ADDENDUM

ADDENDUM NO.: 01
PROJECT NAME: Sheridan Elementary School Annex
PROJECT NO.: 05075
CONTRACT NO.: C1581
DATE OF ISSUE: September 1, 2017

NOTICE OF CHANGES, MODIFICATIONS, OR CLARIFICATIONS TO CONTRACT DOCUMENTS

TITLE:
SECOND FLOOR ELECTRICAL POWER PLAN
 SHEET
EP02

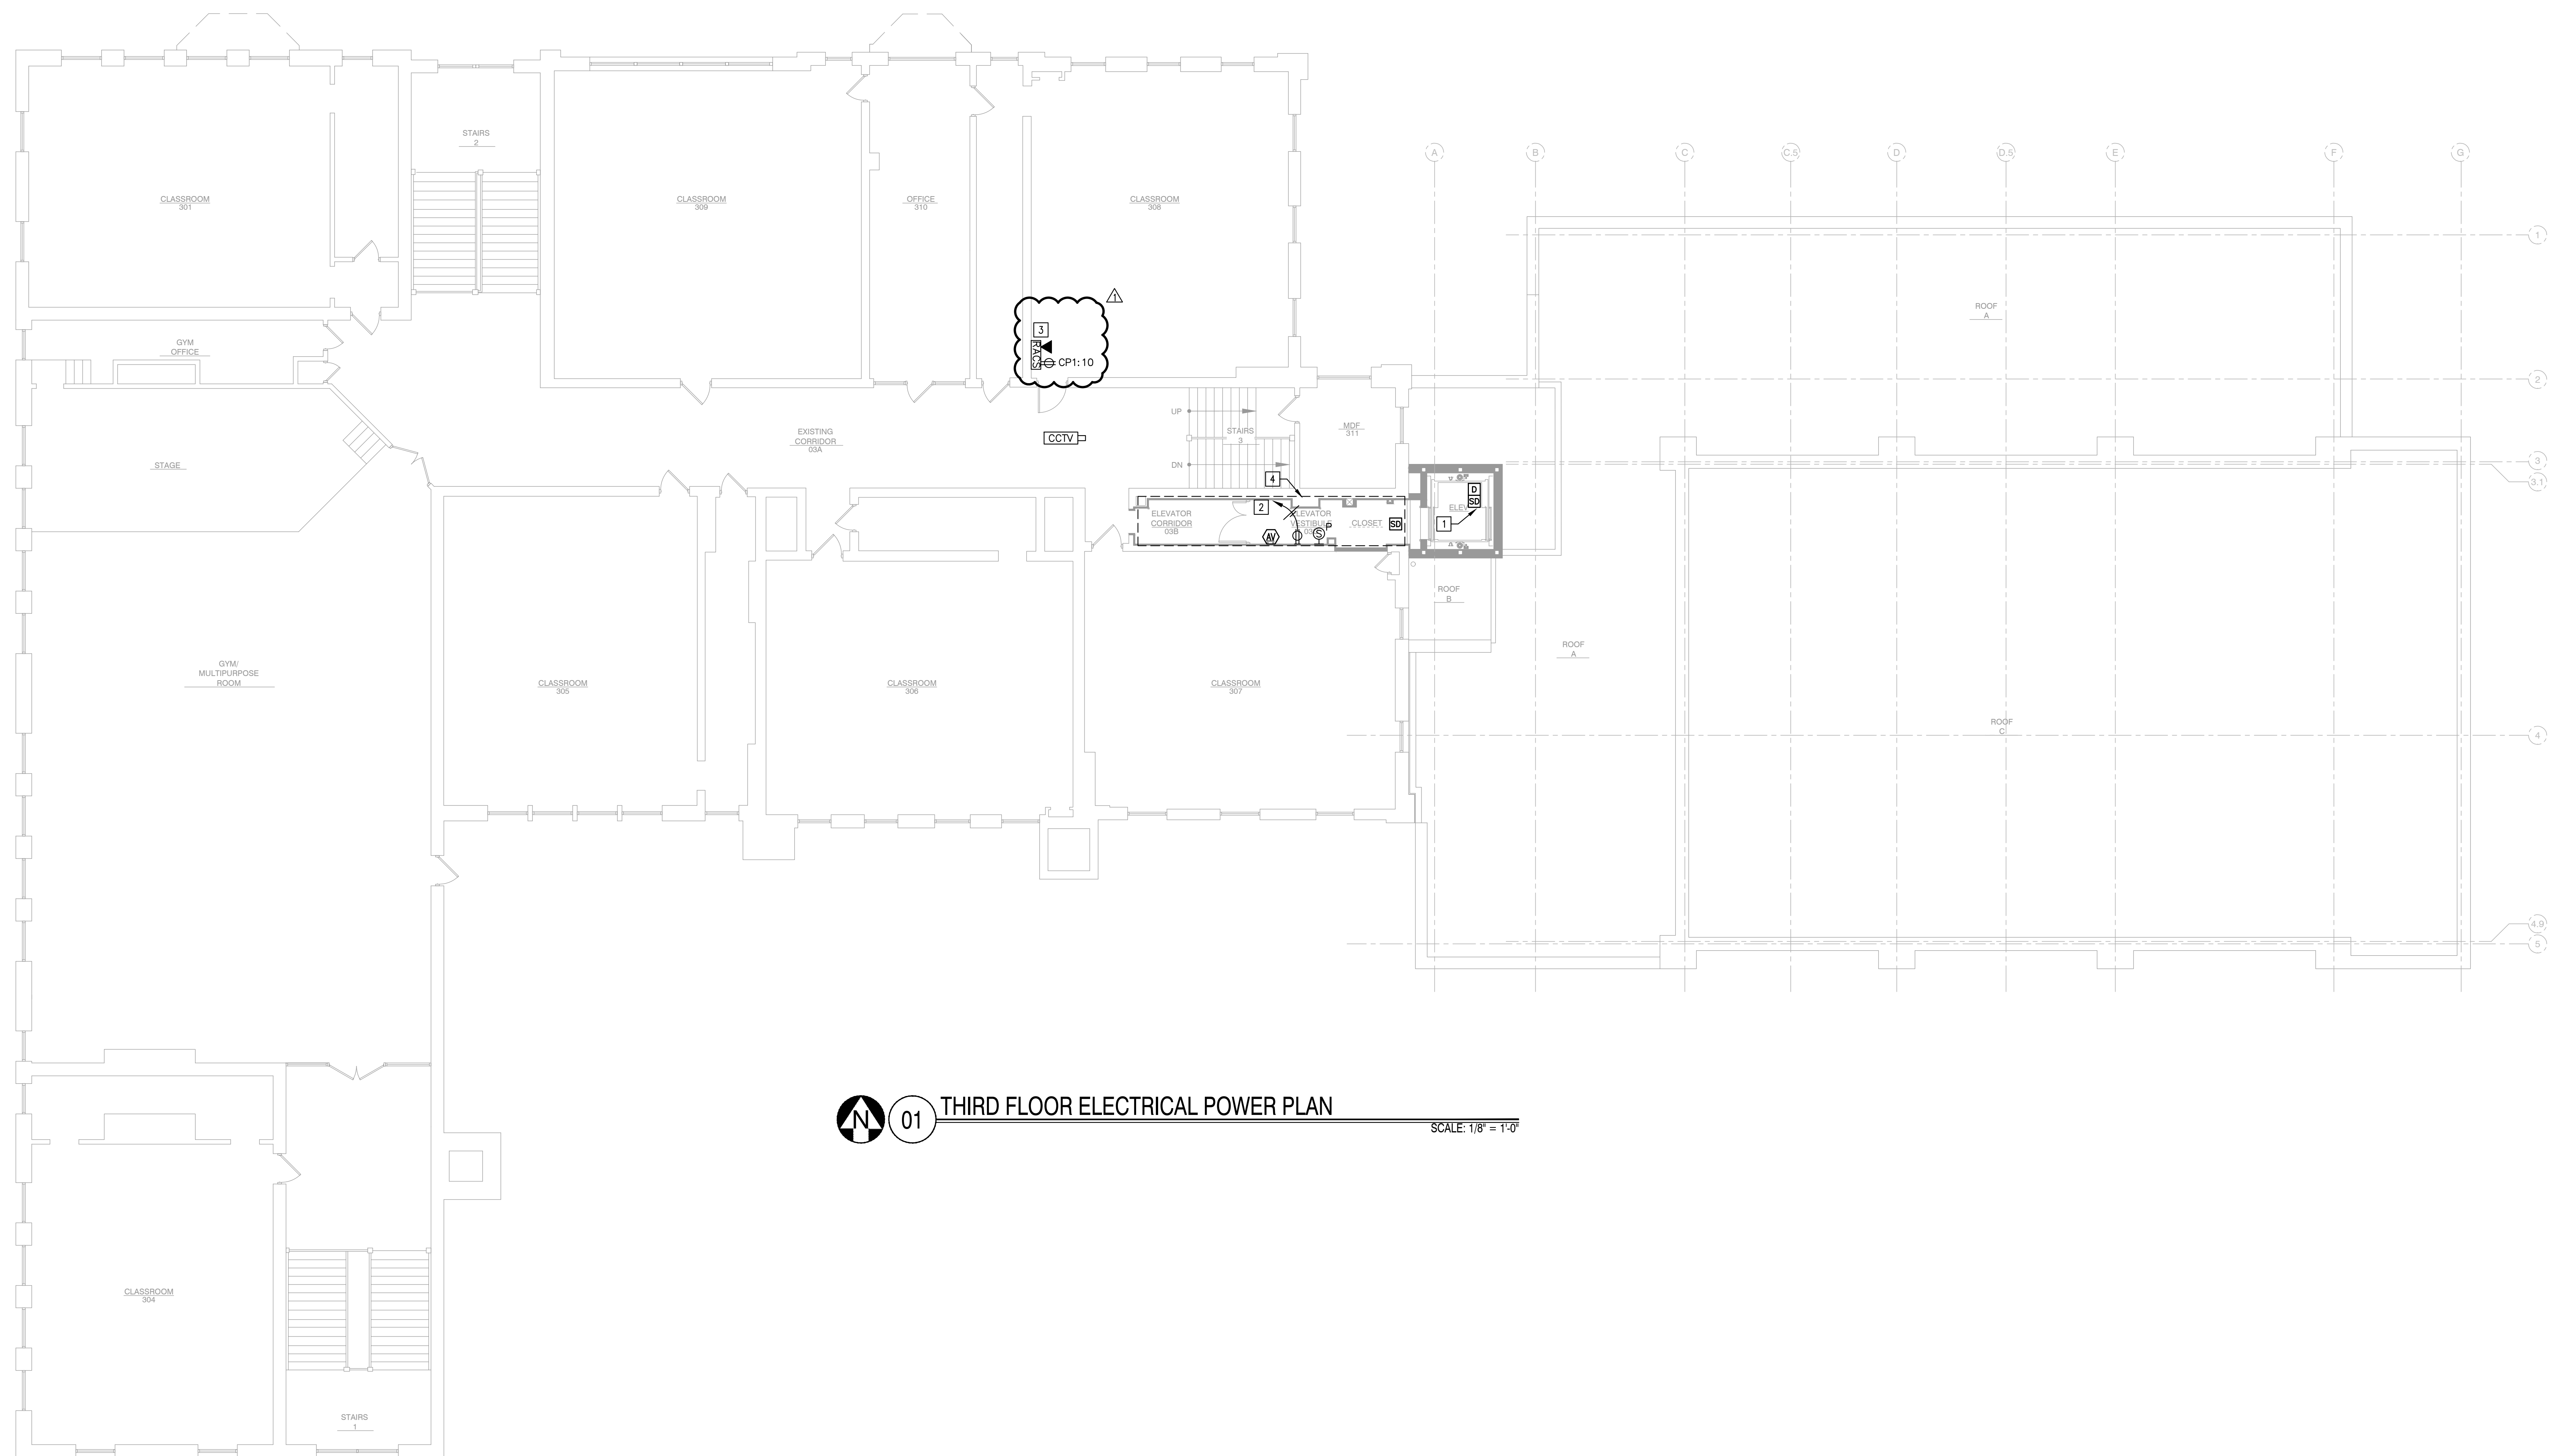
- Change 16. REVISED** – Drawing No. EP01 – FIRST FLOOR ELECTRICAL POWER PLAN: Relocated the Area of Rescue in Classroom 108
- Change 17. REVISED** – Drawing No. EP02 – SECOND FLOOR ELECTRICAL POWER PLAN: Relocated the Area of Rescue in Classroom 208
